DEPARTMENT	REVIEWER	DATE OF REVIEW	STATUS OF PROJECT	
PLANNING	Bethany Ross	07/21/2022	Approved w/ Comments

07/21/2022: SP2022-041; Site Plan for Helping Hands

- I.1 This is a request by Jeff Carroll of Carroll Architects, Inc. on behalf of Jon Bailey of Helping Hands for the approval of a Site Plan for a Commercial Building on a 8.869-acre tract of land identified Lot 1, Block A, Waggoner Gardens Inc. Addition, City of Rockwall, Rockwall County, Texas, zoned Commercial (C) District, addressed as 950 Williams Street.

LANDSCAPE PLAN

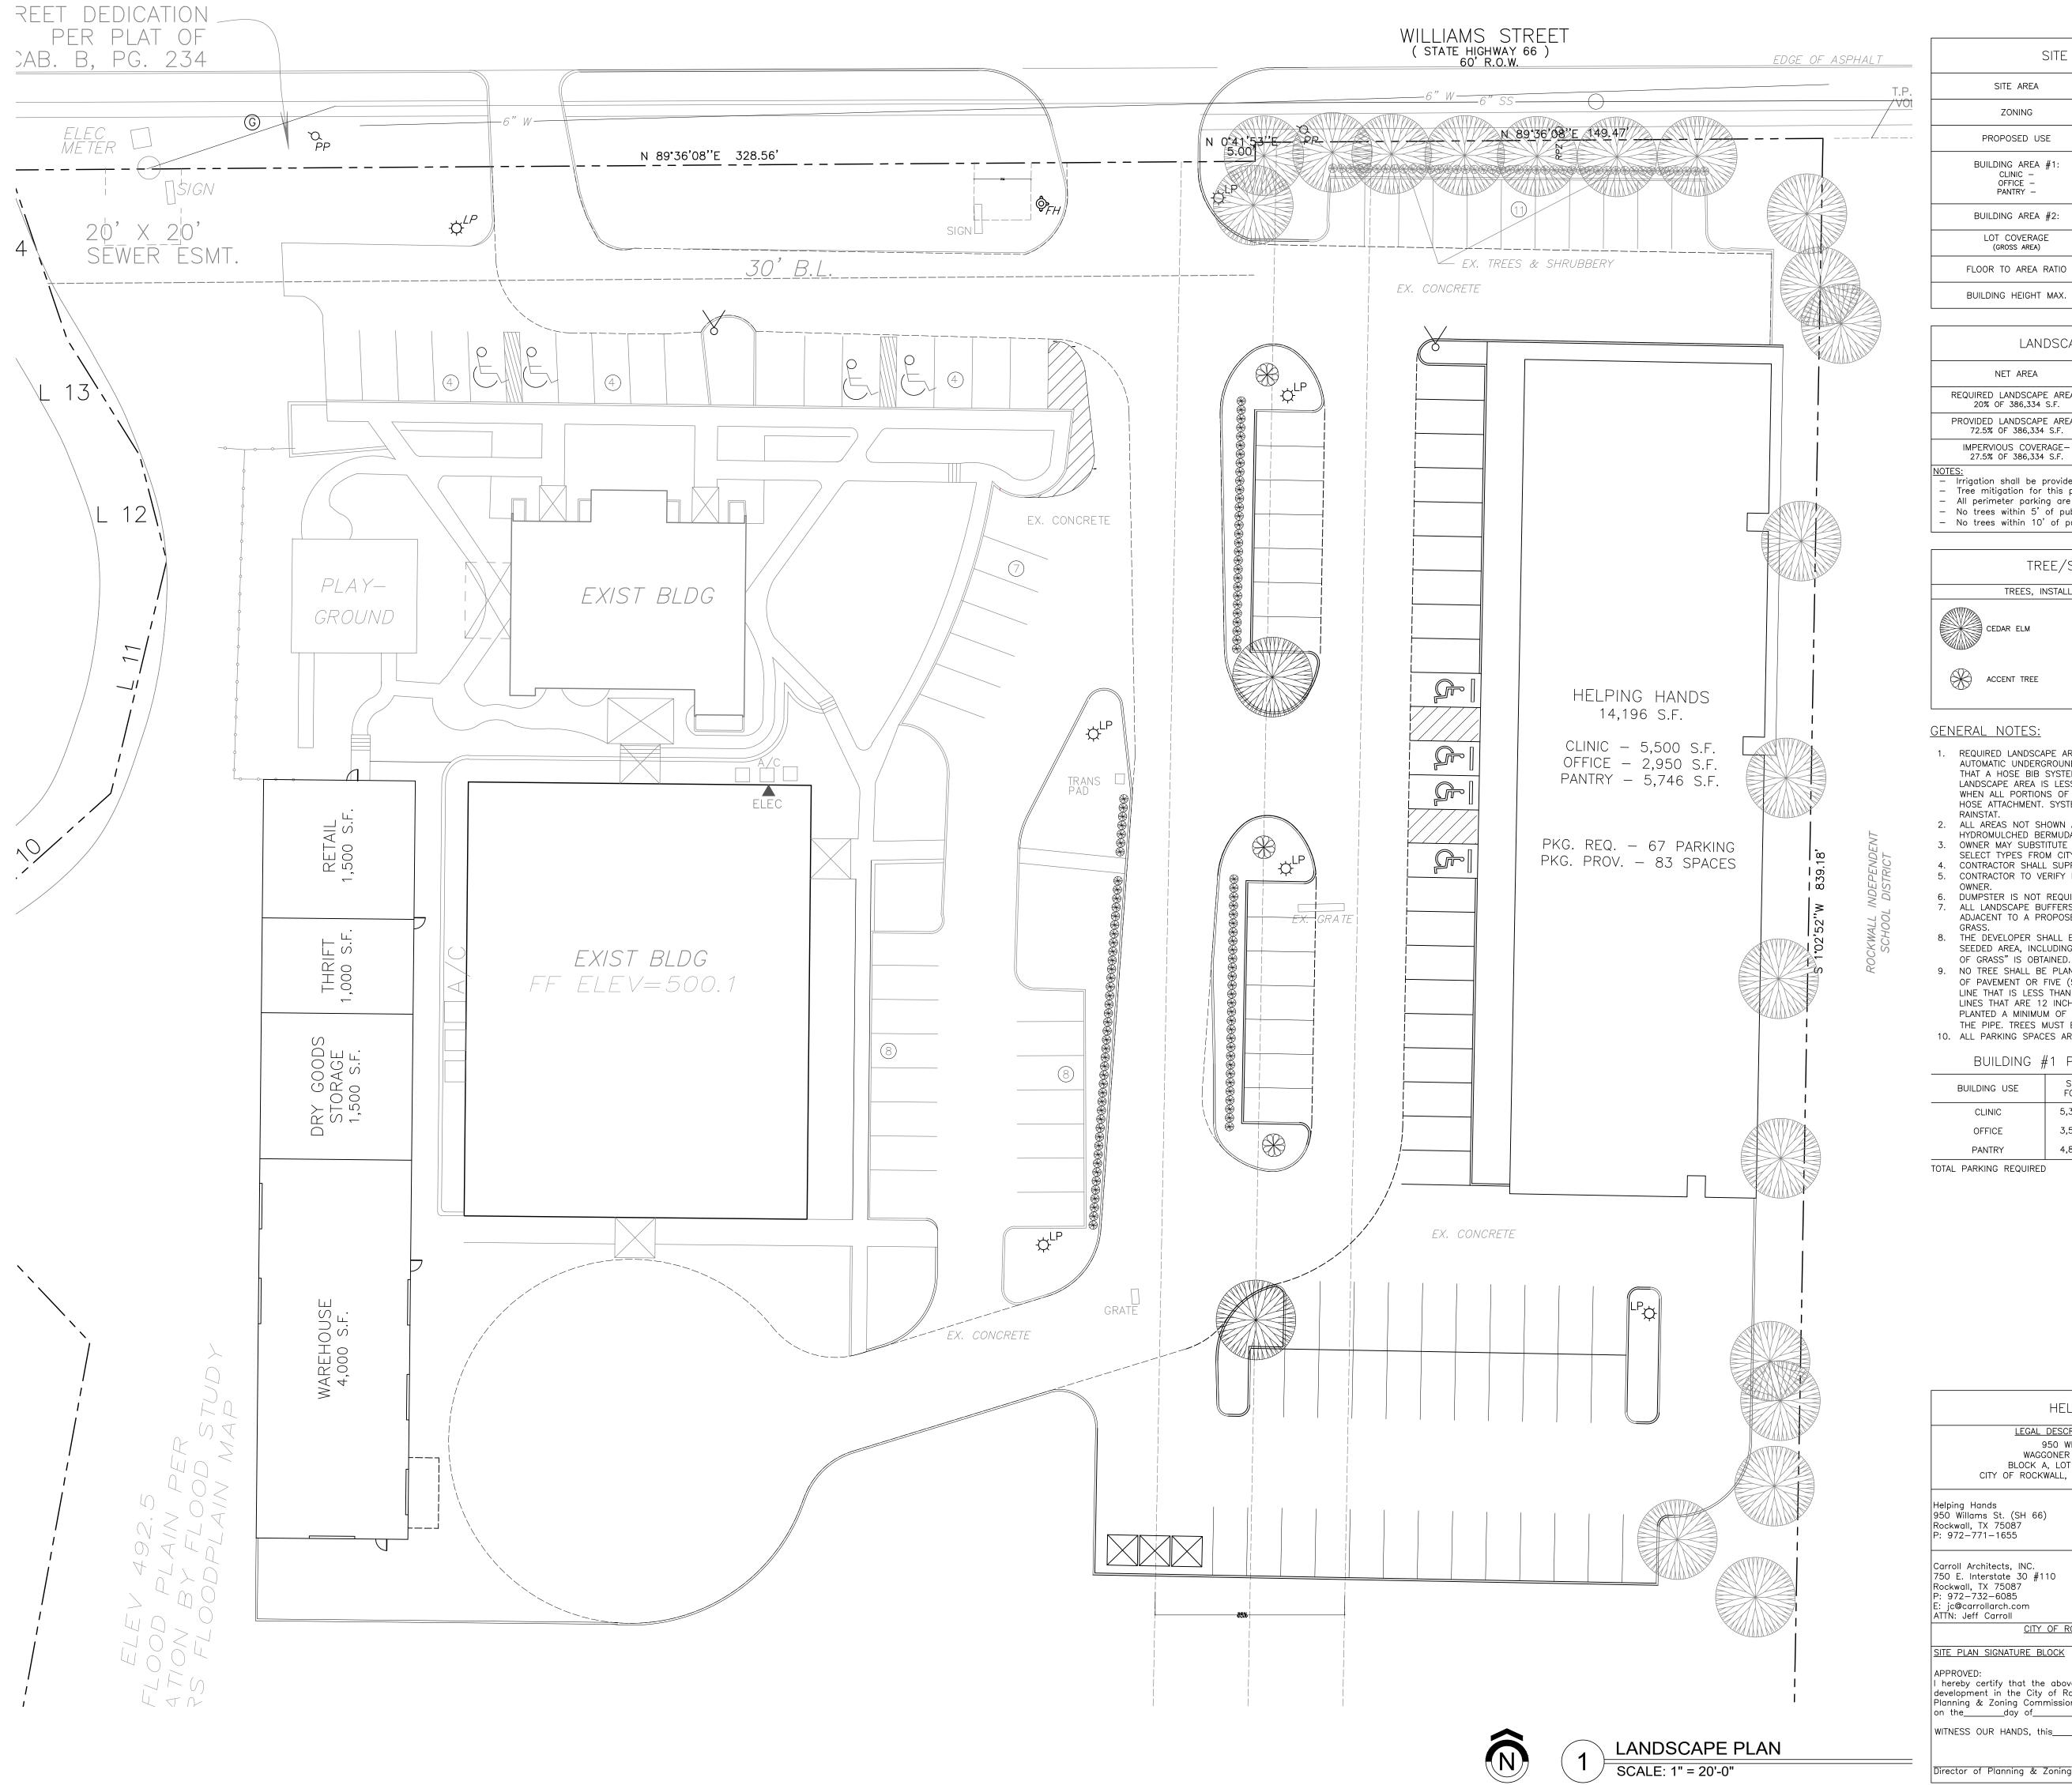
- (1) The entire site needs to be reflected in the landscape plan and brought up to current landscape standards since the applicant is proposing more than a 2,000 SF increase in building size. (Subsection 02.01.A1(b), Article 08, UDC)

- (2) Please add a graphic scale to the landscape plan. (Subsection 03.04.A, of Article 11, UDC)
- (3) A landscape buffer of 10' is required along Williams Street. The landscape buffer shall incorporate ground cover, a built-up berm and shrubbery along the entire length of the frontage. Berms and shrubbery shall have a total minimum height of 30-inches. In these areas a minimum of one (1) canopy tree and one (1) accent tree shall be incorporated into the landscape buffer per 50-linear feet of frontage along the adjacency of Williams. (Subsection 05.01.B(1), Article 08, UDC)

- (4) Identify visibility triangles for all driveway intersections and public streets. (Subsection 01.08, of Article 05)
- (5) Ensure all trees are planted far enough away from utility lines; confirm that the Engineering Standards are being met. (Subsection 05.03. E, of Article 08)

- (8) The square footage of land uses does not match in the table and on the building layout. Please provide correct square footage for all land uses of both buildings. Subsequently, check the parking calculations.

- (9) The parking requirements for a clinic are 1/200 not 1/150. Please revise and recalculate parking. (Table 05, Article 06, UDC)
- (10) Parking Calculations for building #2 are still needed. (Table 05, Article 06, UDC)
